Te Karaka SH2 Road Raising
Preliminary Design Stage Safe System Audit Report
Prepared for Gisborne District Council

REVISION 0 - SEPTEMBER 2026

This is a Preliminary Design Stage Safe System Audit (SSA) for the Te Karaka SH2 Road Raising Project.

Figure 5.1-3: Drop-off into ditch / drain on SH2 (Site 1)

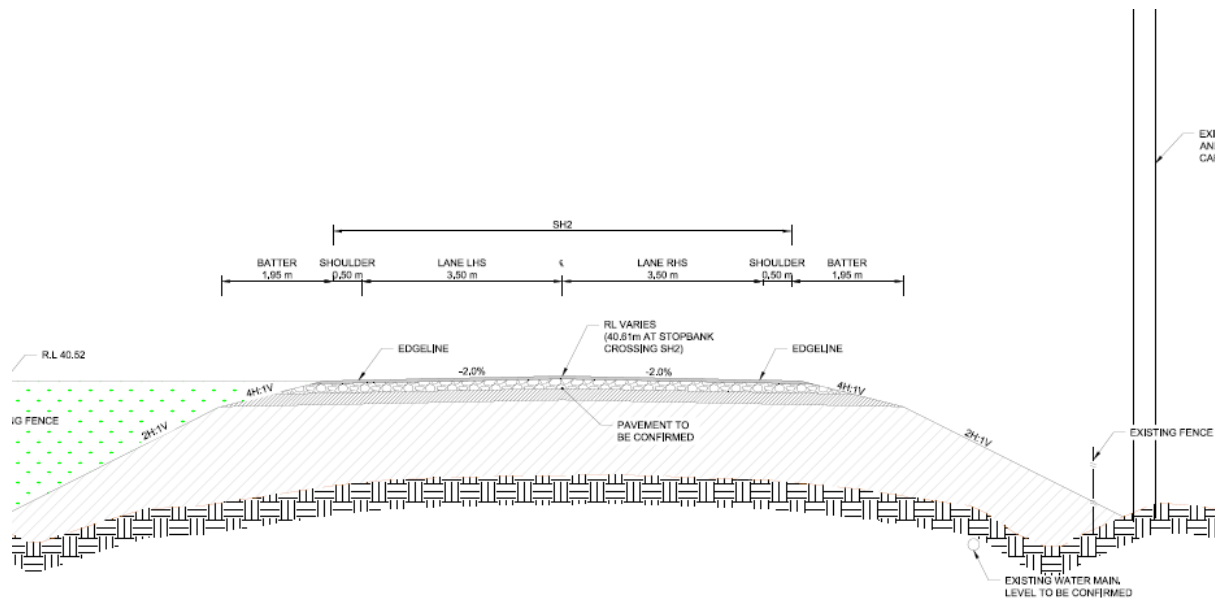
At both SH2 sites, the proposed road raising will result in a roadside environment that provides limited opportunity for drivers to recover if they leave the carriageway.

The typical cross-section indicates 0.5 m shoulders and a roadside batter arrangement comprising a short 1.95 m wide 1:4 slope, followed by a 1:2 slope. While the initial 1:4 batter may provide some limited traversable width, it is not sufficient to function as a forgiving roadside. The narrow shoulder further reduces the available recovery area. In combination, this means an errant vehicle may have little opportunity to regain control before encountering a steeper slope that increases the potential for loss of control, rollover, or descent into the roadside.

This is of particular relevance at Site 01, where a drain / ditch with a noticeable drop-off is present on the north side of the road, together with rigid roadside objects including trees. A curved is also present along this site, which in general terms results in a higher likelihood of loss of control crashes. At Site 02, non-frangible power poles are present near the road, predominantly on the southern side, although one is also located on the northern side. While most of these poles appear to sit outside the road reserve, two are relatively close to the carriageway. In these locations, the proposed cross-section may not only provide limited recovery space, but may also direct errant vehicles toward existing roadside hazards. The current preliminary design information does not clearly show how these hazards would be addressed as part of the works.

Of relevance, SH2 sites sit within a high-speed rural environment, and the existing crash history includes loss of control crashes some with high severity outcomes. While the affected lengths are relatively localised, an unforgiving roadside at these locations may increase the severity of outcome where a vehicle departs the carriageway. The combination of narrow shoulder width, limited traversable batter width, steeper outer slopes, and existing roadside hazards may therefore provide a reduced margin for driver error than would be desirable on a 100 km/h state highway.

It is acknowledged that the proposal is not entirely dissimilar to the existing cross-section and roadside environment. However, the raised road levels would increase the height of roadside drops relative to the existing situation, which may increase crash severity if a vehicle leaves the carriageway. There remains a risk that the proposed works could introduce or retain a roadside condition in which some errant vehicles would have limited opportunity to recover before encountering a rollover hazard or rigid roadside object.

1. *Identify roadside hazards within the project extent and confirm whether these should be removed, relocated, or protected.*
2. *Review the proposed cross-section at both SH2 sites, including whether additional recovery width can be achieved through shoulder widening and / or flatter roadside slopes, or alternatively whether roadside barrier protection is required.*

Probability Rating:	Severity Outcome Rating:
<i>The probability of a crash is Unlikely</i>	<i>Crashes are likely to be Serious</i>
Design Team Response: <i>Noted. The designer accepts that the road raising increases the height difference from the new road to the bottom of the batter slope. Designer to review the recommendations to test the feasibility for shoulder widening, noting that this may encroach into private land. Notwithstanding this the designer will also investigate the inclusion of a safety barrier. This work is to be undertaken as part of the detailed design phase.</i>	
Safety Engineer:	Jamie Gallacher – GDC Major Projects Manager.
Client Decision:	<i>Client preference is for inclusion of a safety barrier as suggested by the design team at WSP.</i>
Action Taken:	Designer to include a safety barrier.

Figure 5.1-4: Vertical Alignment on the approach to the Rangatira Bridge

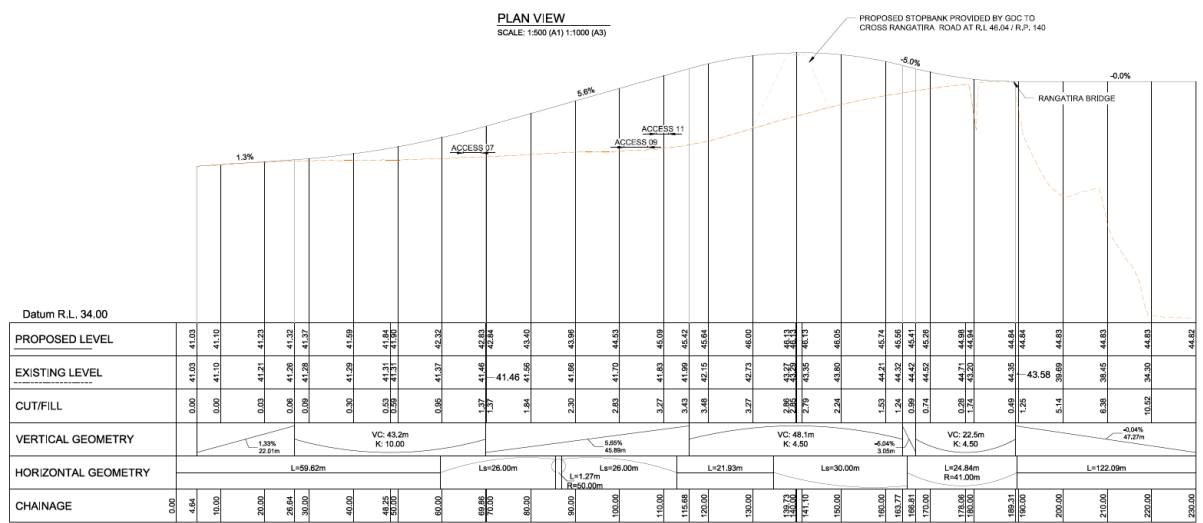
The proposed approach to Rangatira Bridge is likely to provide limited opportunity for drivers to safely respond when encountering opposing traffic near the bridge.

The proposed road raising adjacent to the bridge introduces a crest in the approach to the stopbank crossing, which reduces forward visibility toward the bridge for westbound traffic and reduces the ability of eastbound drivers who have just crossed the bridge to see approaching westbound vehicles compared to the existing situation. This reduction in visibility is not the concern in isolation given the low operating speeds in this area.

The road is also raised by up to approximately 3.5 m near its highest point, effectively increasing the drop-off and severity risk in the immediate vicinity of the bridge relative to the existing situation. At this stage, no barrier protection or other specific roadside treatment is shown to manage that increased risk.

As a result, there remains a risk that drivers meeting near the bridge approach may be required to make late or constrained manoeuvres within a narrow and unforgiving environment. If a vehicle departs the carriageway, the steep embankment slopes and unprotected drop-offs may increase the likelihood of rollover or a more severe run-off-road outcome. The single-lane bridge arrangement and priority-controlled operation further increase the importance of providing a clear and forgiving approach where drivers can see, assess and respond safely to the presence of other vehicles.

1. Review the proposed cross-section and verge treatment to ensure that vehicles can safely manoeuvre when encountering opposing traffic on the approach to the bridge.
2. Review the raised embankment roadside treatment near the bridge, including whether barrier protection, flatter slopes or other mitigation is required to address the increased drop-off hazard.
3. Confirm that the final bridge approach arrangement provides a clear, legible and safe operating environment for drivers approaching from both directions.

Probability Rating:	Severity Outcome Rating:
The probability of a crash is Very Unlikely	Crashes are likely to be Serious
Design Team Response: Agree with SAT. The following actions are suggested to be undertaken during detailed design. Response to point 1 – Designer to test opportunity to widen lanes and shoulder on horizontal curve to allow more forgiveness when two vehicles pass one another. Response to point 2 – Designer to include safety barriers to improve delineation of the horizontal curve and to prevent vehicles from leaving the road. Response to point 3 – Designer to include appropriate advanced warning and curve warning signage to alert drivers.	
Safety Engineer:	Jamie Gallacher – GDC Major Projects Manager.
Client Decision:	Agree with the response from the Design Team at WSP.
Action Taken:	Designer to include within Detailed Design phase.

Figure 5.1-5: Proposed Cross-section on the approach to the Rangatira Bridge

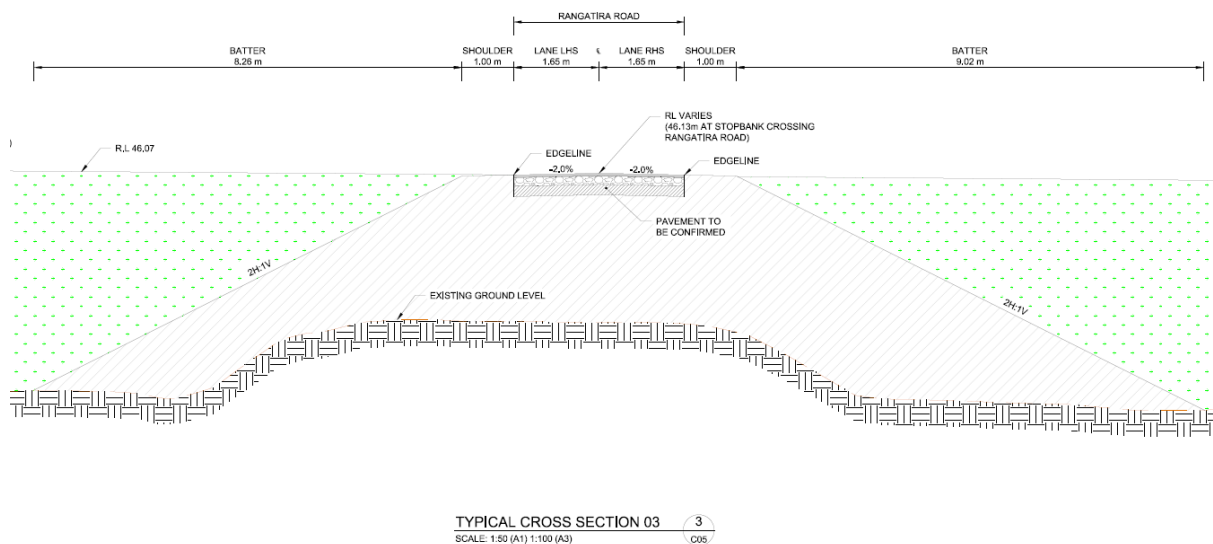
The more important issue is the way this reduced visibility combines with the proposed bridge approach cross-section. The carriageway is proposed to be approximately 3.3 m wide, with 1.65 m lanes, 1 m verges on either side, and steep 1:2 embankment slopes beyond. This means that when opposing vehicles meet on the approach to the bridge, there is limited width available for manoeuvring and no clearly formed passing area to enable one vehicle to move aside in a controlled manner, particularly if one or more heavy vehicles are involved. While the 1 m verge may provide some nominal space for evasive tracking, it is unformed and sits immediately adjacent to a steep drop. As such, it would provide only limited practical refuge, may deteriorate over time if repeatedly used by vehicles, and may bring vehicles uncomfortably close to the edge hazard.

While visibility toward the bridge is currently restricted in practice by vegetation, review of the existing layout suggests that when vegetation maintenance is undertaken, approaching drivers are able to observe the bridge earlier and use an approximately 25 m long, 3 m wide sealed area within the frontage of properties 9 and 11 to pass one another. The proposal does not retain an equivalent passing provision, and therefore may result in a more constrained environment for opposing vehicles than exists currently.

Figure 5.1-6: Existing ATP markings on site 1

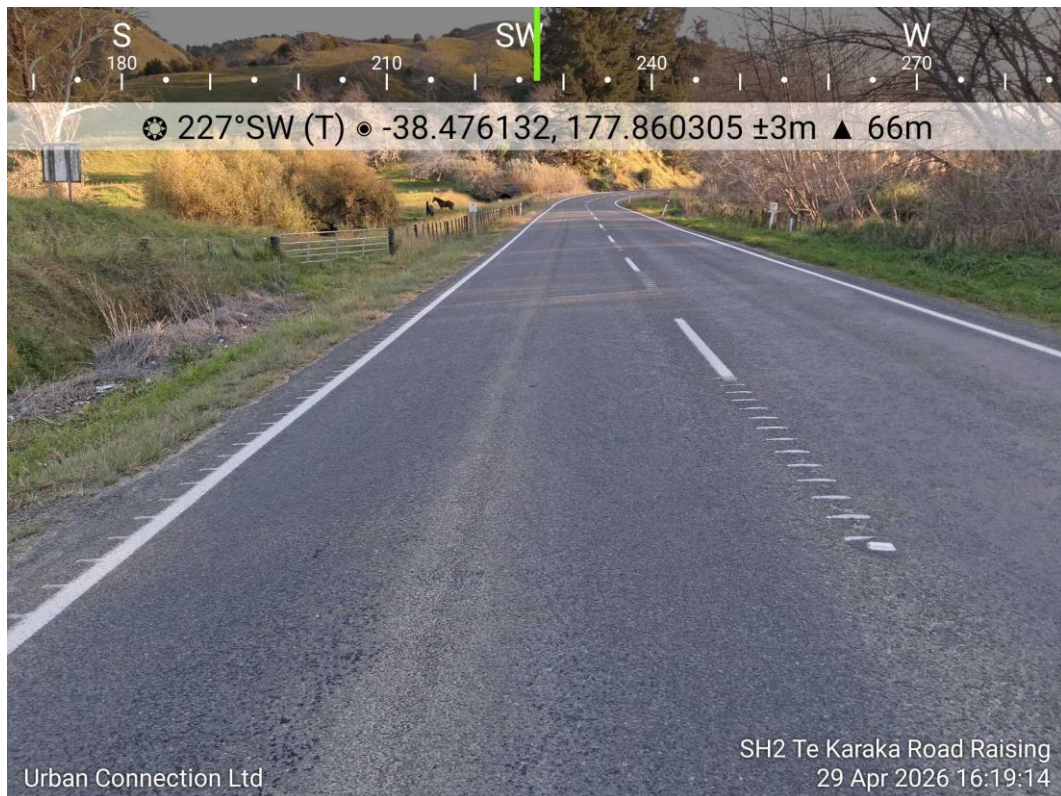
During the site visit, it was noted that audio tactile profiled markings are currently present at Site 01. These should be addressed as part of the detailed road marking design. It was also observed that a single chevron sign is currently provided on the curve at Site 01, whereas where chevron delineation is required, a series of signs would typically be expected rather than a single isolated sign.

1. Review the required road markings and signage as part of the next design stage.
2. Confirm how existing audio tactile profiled markings would be reinstated or adjusted through the works.
3. Review curve delineation and sign provision and assess whether the proposed works affect the visibility of existing signs at both sites.
4. Consider whether no-passing lines should be provided.

Probability Rating:	Severity Outcome Rating:
The probability of a crash is N/A	Crashes are likely to be N/A
Design Team Response: Point 1 – Agree with SAT. Point 2 – Noted and designer to include specific details on how the ATP will merge with the existing road. Point 3 – Agree with SAT. Designer to revisit existing signage locations and amend to align with overall project intent. Point 4 – Agree with SAT. New road layout to include no passing lines due to the vertical alignment changes potentially impacting forward visibility.	
Safety Engineer:	Jamie Gallacher – GDC Major Projects Manager.
Client Decision:	Agree with response of the Design Team at WSP.
Action Taken:	Designer to consider in Detailed Design as noted.

Figure 5.1-9: Accessways and gates on SH2 and Rangatira Road

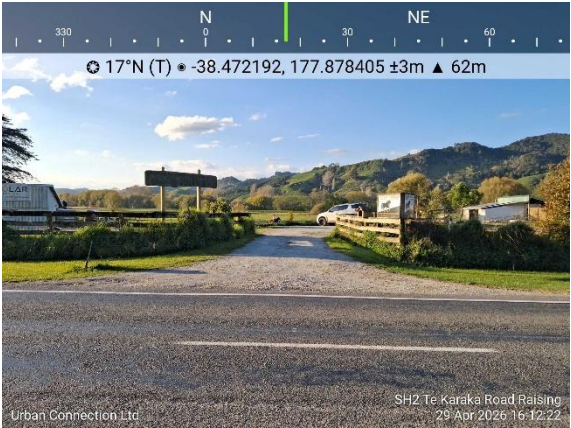
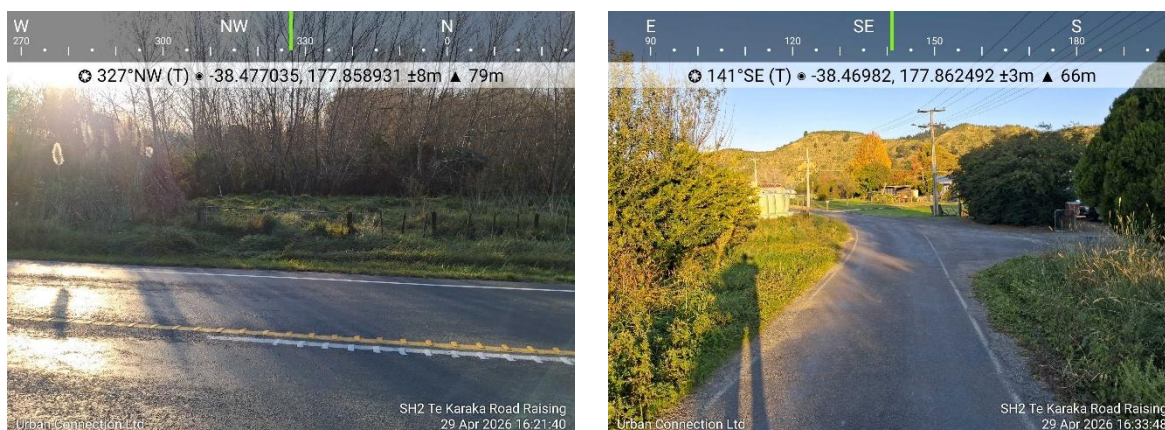
A number of accessways and / or gates on SH2 and Rangatira Road are expected to be affected by the proposed road raising. At this stage, the preliminary design information does not clearly show how these access points would tie into the proposed road levels and whether they are to be sealed as part of this project.

This should be reviewed as the design develops to confirm that vehicle movements to and from these accessways and gates remain suitable. In particular, steepened access gradients or abrupt tie-ins may make entry and exit movements more difficult, and could delay safe vehicle entry and exit, particularly in wet or slippery conditions.

1. Review all affected accessways and gates as part of the next design stage.
2. Confirm that tie-ins to the proposed road levels provide suitable gradients and vehicle manoeuvring conditions for safe entry and exit.
3. Confirm that all affected driveways are to be sealed.

Probability Rating:	Severity Outcome Rating:
The probability of a crash is N/A	Crashes are likely to be N/A
Design Team Response: Noted. SAT may not be aware that some properties are to be relocated / demolished as part of the stopbank improvements and as such driveway access is not required. Designer to ensure that all properties that remain are appropriately designed to ensure they are fit for purpose and to no introduce safety risks.	
Safety Engineer:	Jamie Gallacher – GDC Major Projects Manager.
Client Decision:	Agree with response of the Design Team at WSP.
Action Taken:	No Action.

Figure 5.1-10: Overhead power cables on Rangatira Road

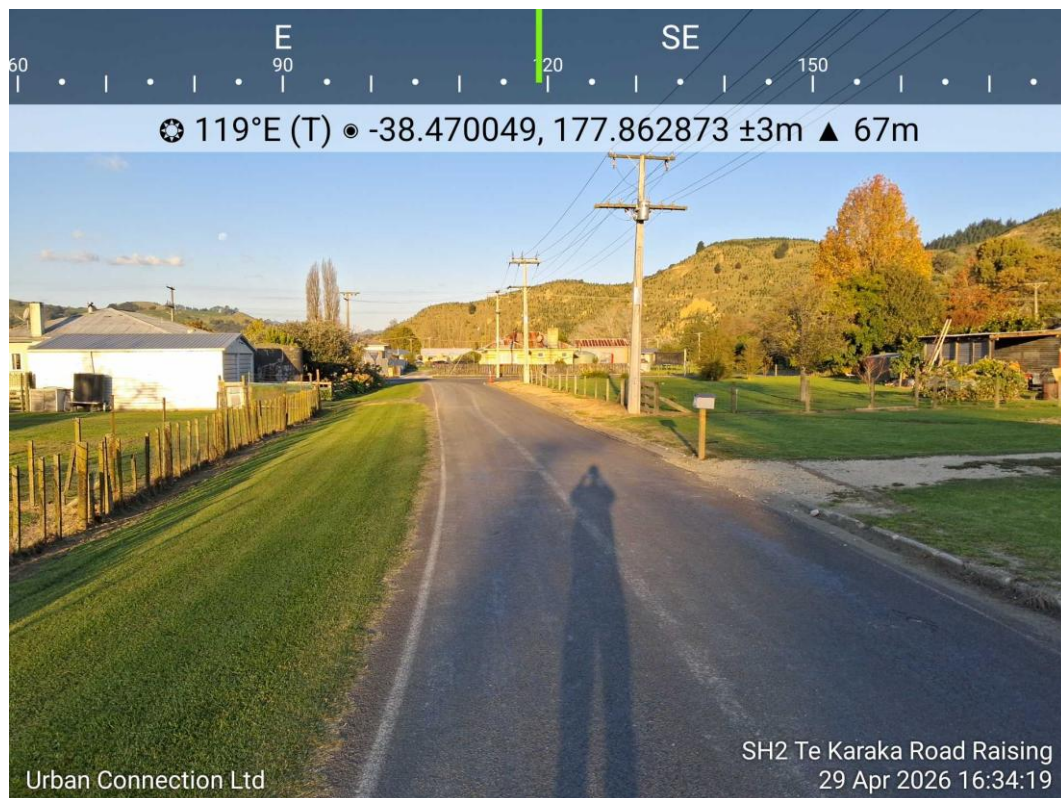
The proposed road raising is expected to affect existing utilities at a number of locations, particularly overhead power lines, as the change in road level may reduce the available clearance relative to the existing situation. While this is acknowledged in parts of the design information, the current preliminary design does not clearly show how utility constraints would be addressed.

This is relevant on both SH2 and Rangatira Road, where overhead power infrastructure is present within or adjacent to the project area. It is important that the effect of the raised road profile on overhead clearances is reviewed as the design develops, including at locations where vehicles may track closer to the road edge or use adjacent verges and accessways. More generally, other existing services and utilities within the project extent should also be reviewed to confirm whether protection, adjustment, or relocation is required.

1. Review the effect of the proposed road raising on overhead power line clearances throughout the project extent.

Probability Rating:	Severity Outcome Rating:
The probability of a crash is N/A	Crashes are likely to be N/A
Design Team Response: Noted. Design team has taken into consideration the overhead powerlines, but has not considered the reduced clearance due to the raising of the road. Designer to revisit the clearance requirements and if not achievable, include provision for engaging with utility company to determine the appropriate remedial measure, most likely the reinstatement of a new powerpole and foundation once the new road has been constructed.	
Safety Engineer:	Jamie Gallacher – GDC Major Projects Manager.
Client Decision:	Agree with the response of the Design Team at WSP.
Action Taken:	Designer to allow for provisions as stated.
